Re: *Barbara Crow et al., v. Hometown America, LLC, et al.*, Case 18-cv-12149-LTS
Completion of Stormwater Management System Improvement Projects
Oakhill Settlement Agreement, Section III.C.3 (Doc. 171-1, filed May 6, 2021)

FIELD REPORT #7

Client:	Hometown Oak Hill	Report Date:	December 22, 2020
Project:	Site Observation	A&M Project #:	1830-10
Location:	92 & 93 Such Drive	Contractor:	n/a
Weather:	Rain	Temperature:	40°
Date of Site Visit:	December 14, 2020		
Time:	From: 9:45 am To: 10:15 am		
Present at Site:	Phil Cordeiro (A&M), Peter Conant (Hometown America)		
Reported By:	Phil Cordeiro		
Attachments:	Onsite photograph report

DRAWING TITLE: **GRADING & DRAINAGE PLAN** SHEET No. **C-101**

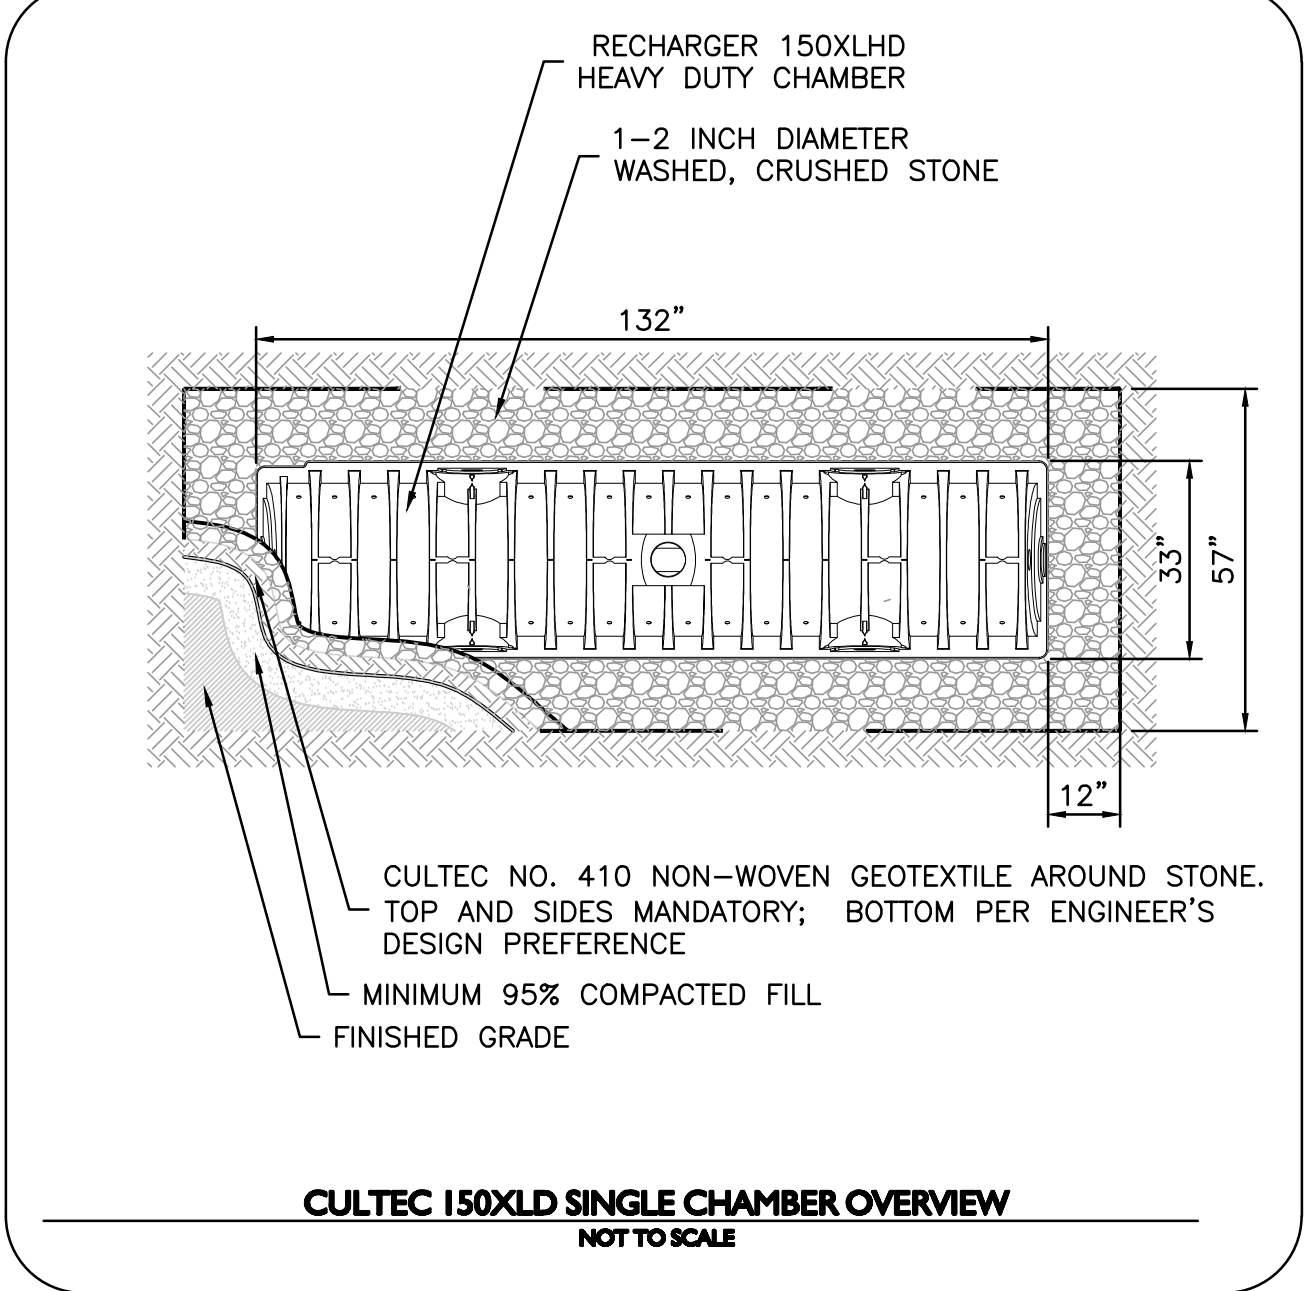
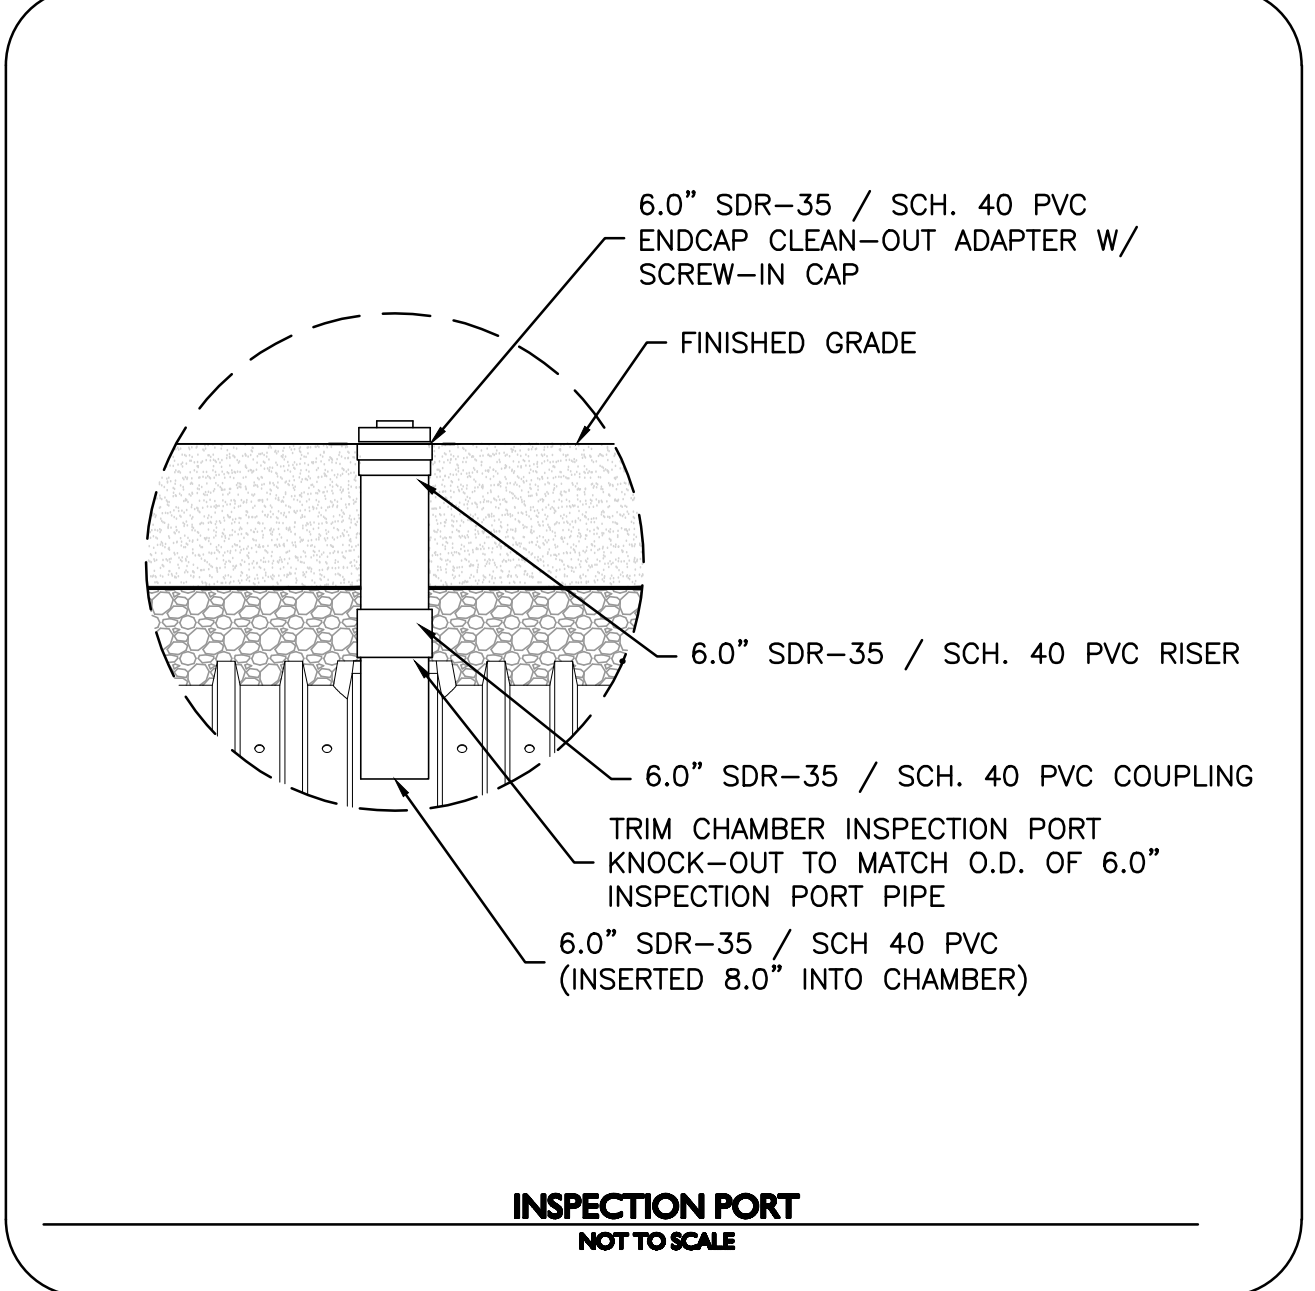
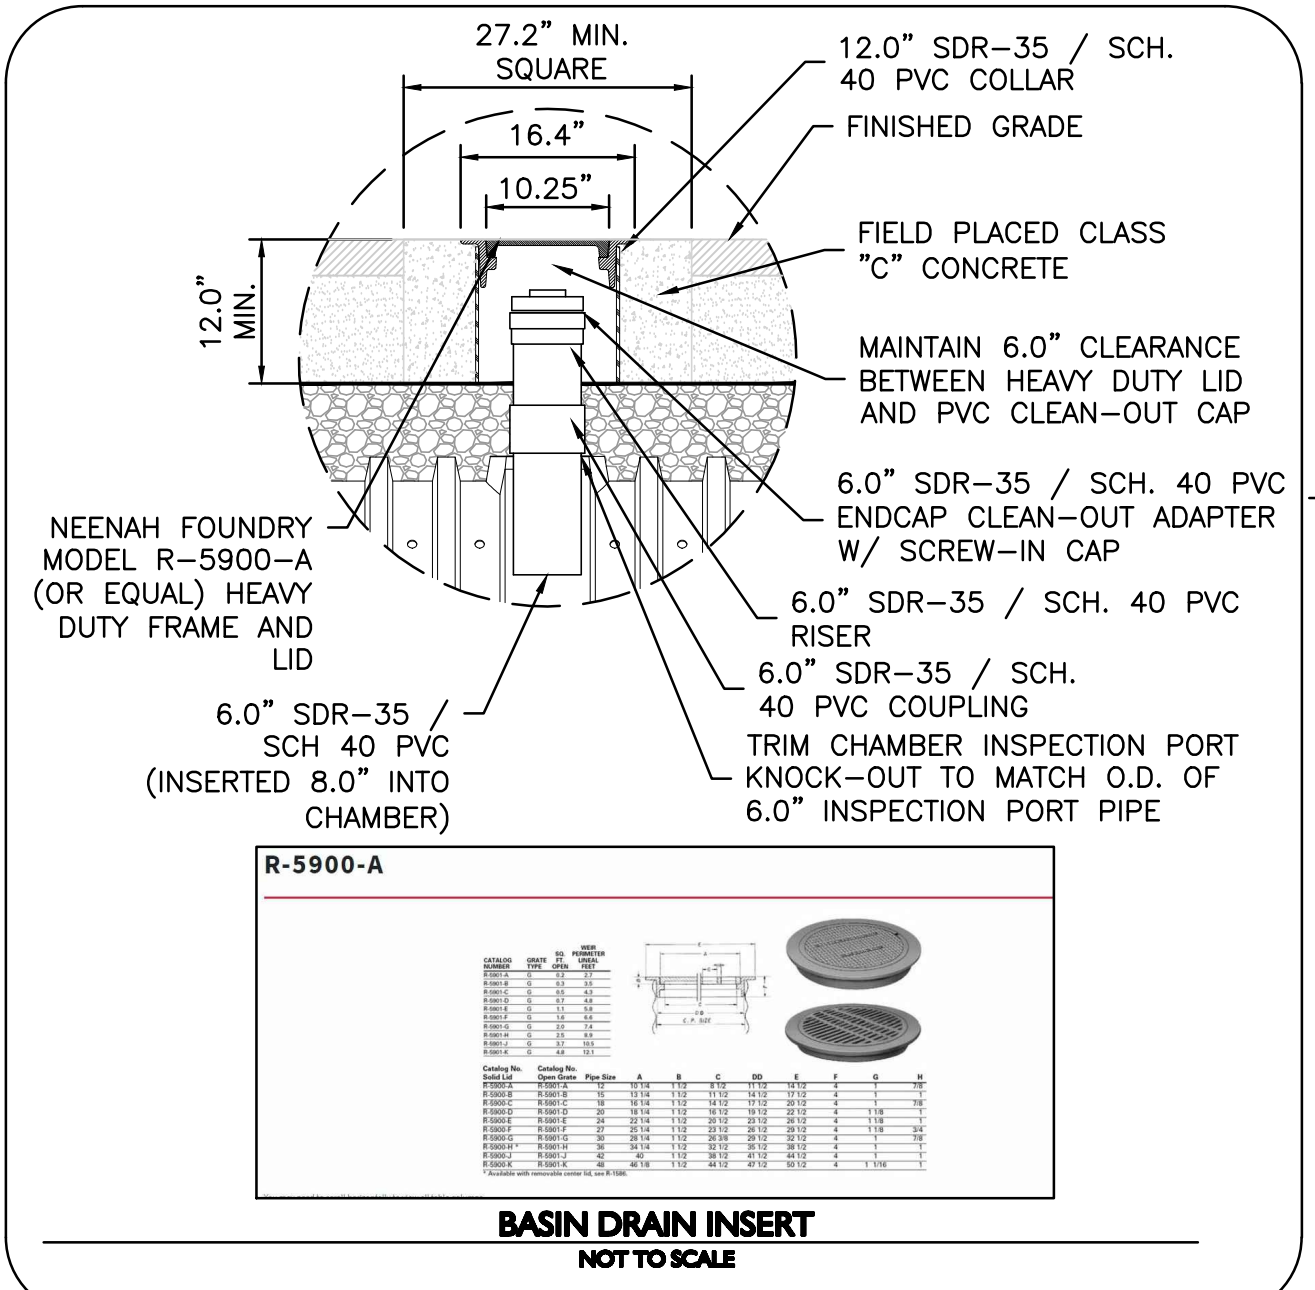
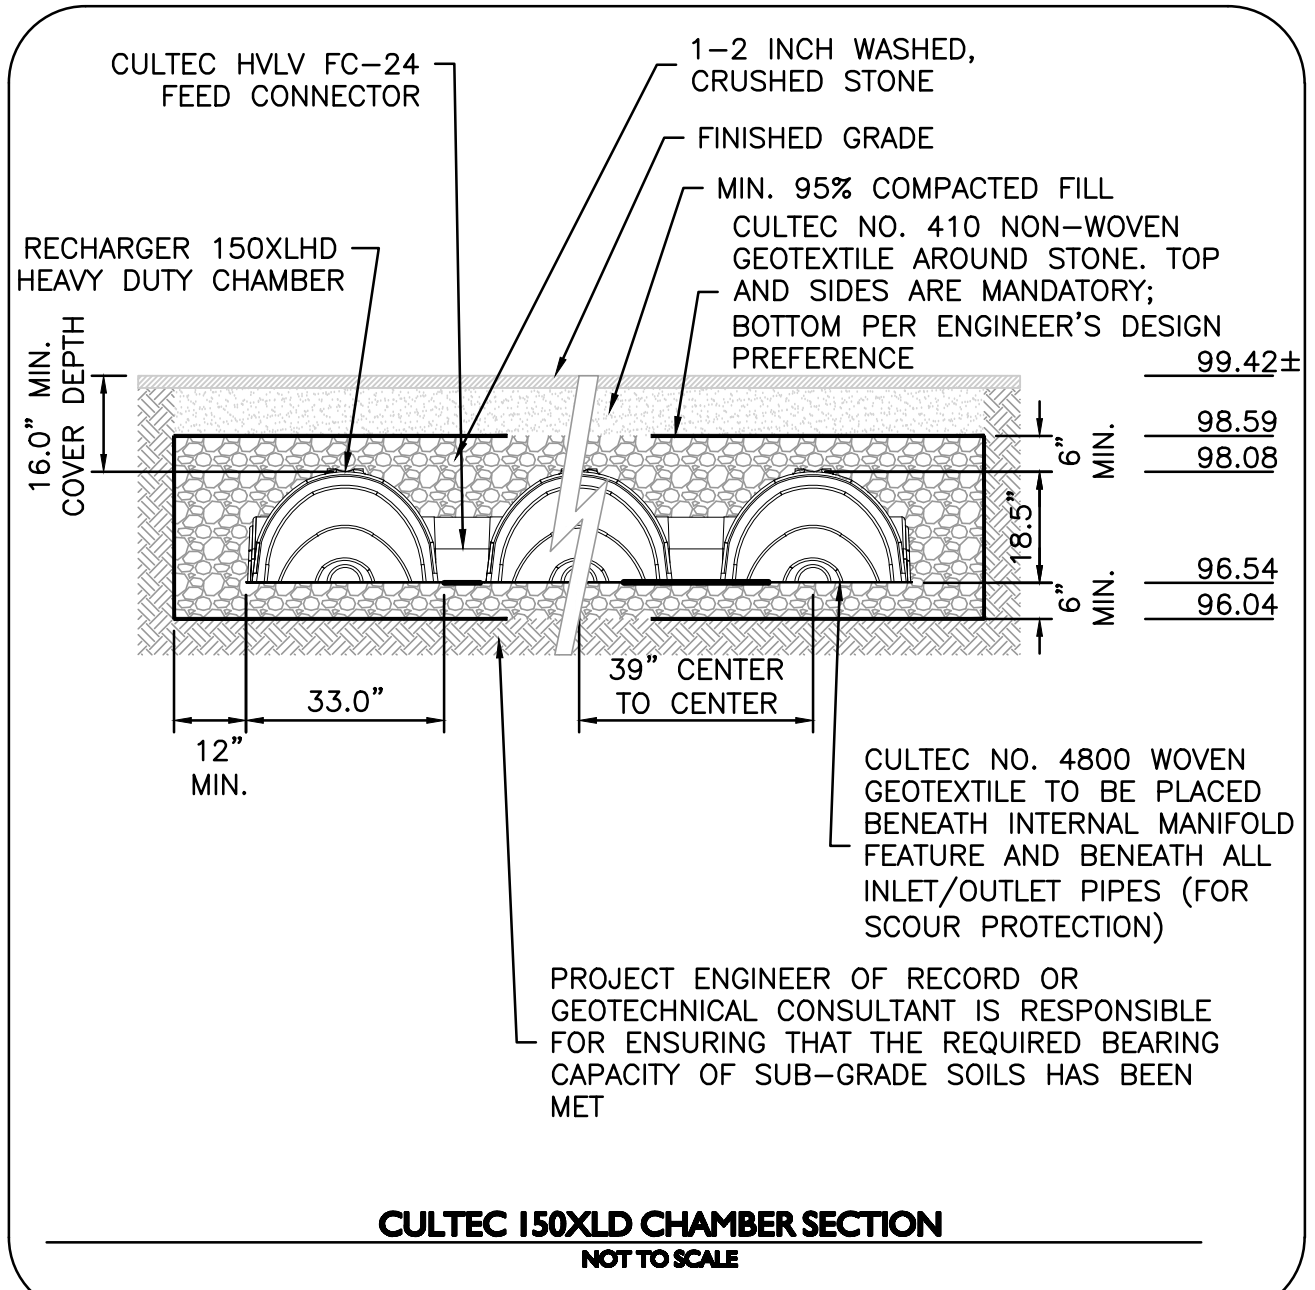
- NOTES:
1. THE INTENT OF THIS PLAN IS TO DEPICT ADDITIONAL GRADING AROUND THE 92/93 SUCH DRIVE HOME SITES TO COORDINATE WITH THE INSTALLATION OF A SUBSURFACE DRAIN SYSTEM. GRADING IS TO SLOPE TOWARD YARD DRAIN BASINS FROM AREAS DEPICTED.

2. DRAIN FIELD SHOWN IS ADOPTED FROM PLAN ENTITLED "PROPOSED GRADING PLAN FOR OAK HILL RESIDENTIAL COMMUNITY" DATED MAY 25, 2018 AS PREPARED BY DECELLE-BURKE-SALA.
